Aircraft Make *SGS* Model *1-26 F* Reg. No. *N33917* Serial No. *637*

Bulletin No. SA-006
Date: 1 March 1989
Page 1 of 1

SUBJECT: Replacement of Seat Back Adjustment Bracket

MODELS AFFECTED: All SGS 1-26D and SGS 1-26E

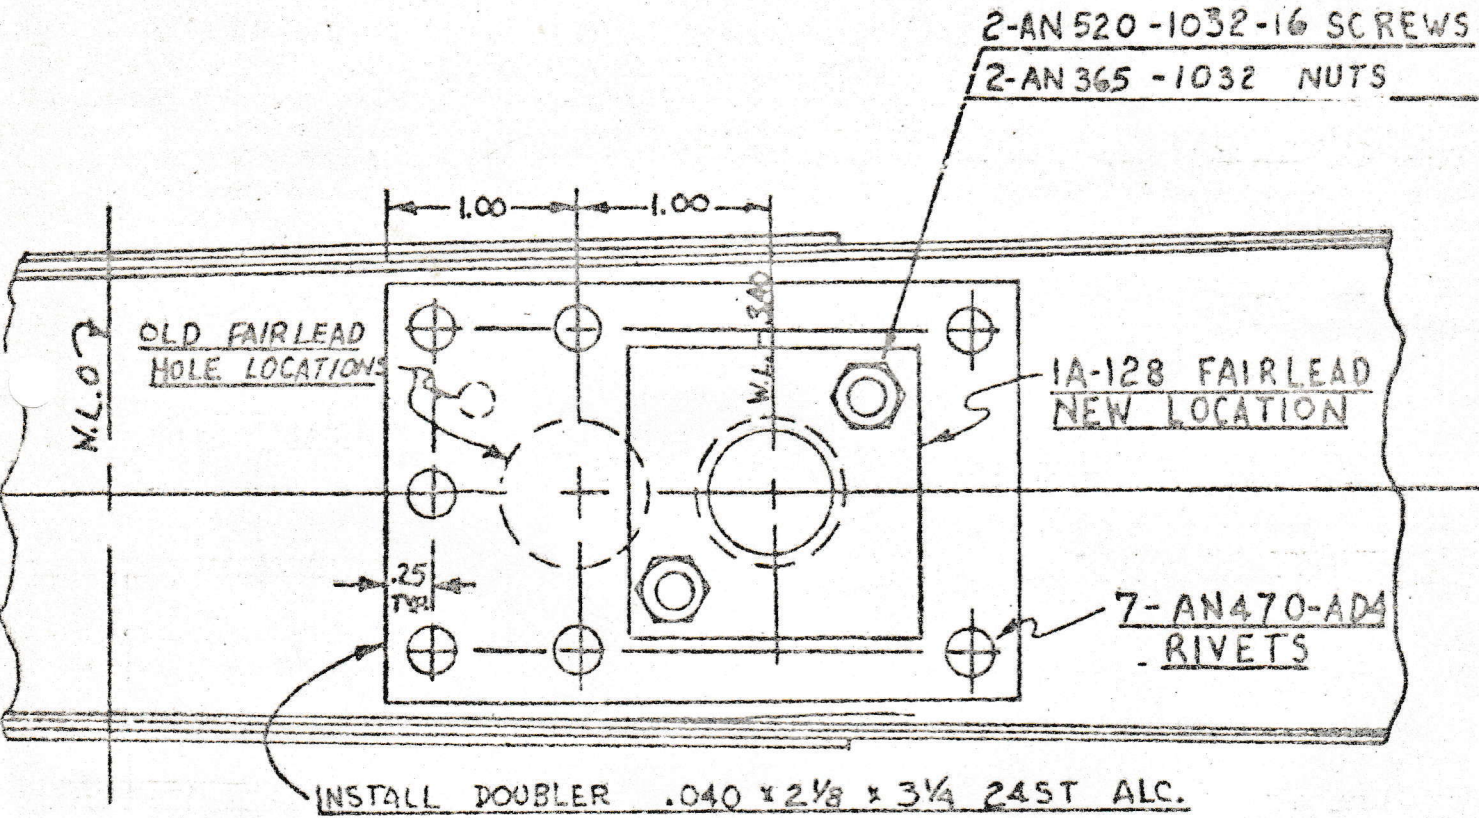
A condition has been discovered which could cause excessive wear on the 26B120-2A Elevator Control Cable at the 1A-128 Fairlead on the Fin Spar. This wear would be induced by the location of the 1A-128 Fairlead at W.L.--2.40. This condition exists on all ships to and including Ship No. 75.

The condition noted may be eliminated by relocation of the 1A-128 Fairlead to W.L. 3.40 according to the attached sketch. Material kits for this work are available upon request.

We recommend the accomplishment of this relocation at the earliest convenience and thorough inspection of the area and parts for indications of wear, each 25 hours until the relocation is made.

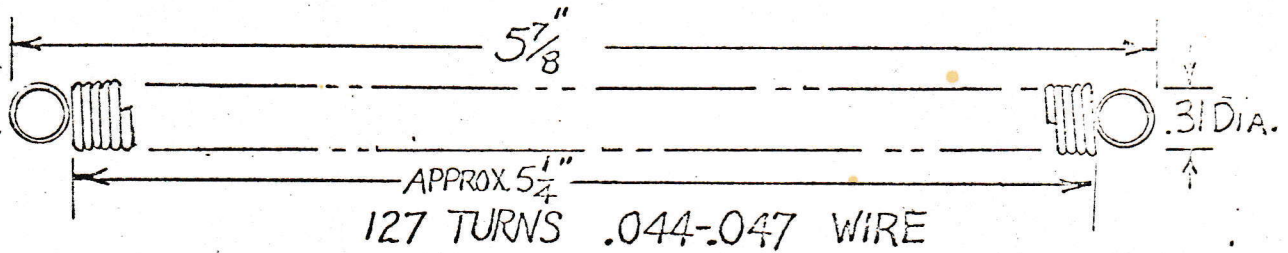
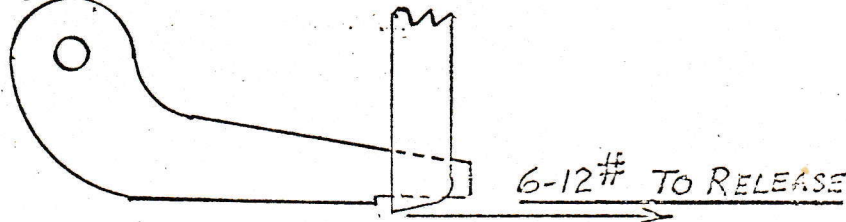
- There are three alternate springs used in the 1-26 tow release mechanism. From field reports from owners, it appears there are cases of excessively high release operating loads. We have run tests and have determined that the best spring is our No. 1A113-1 shown below.

All 1-26's should be equipped with this spring. The installation should be checked by pulling on the release arm just below the hook with a small spring scale. This should require from 6-12 lbs. pressure to release. (See note on page 2).

If you have another type of spring in your ship than the 1A113-1, please advise us and we will ship one at no charge.
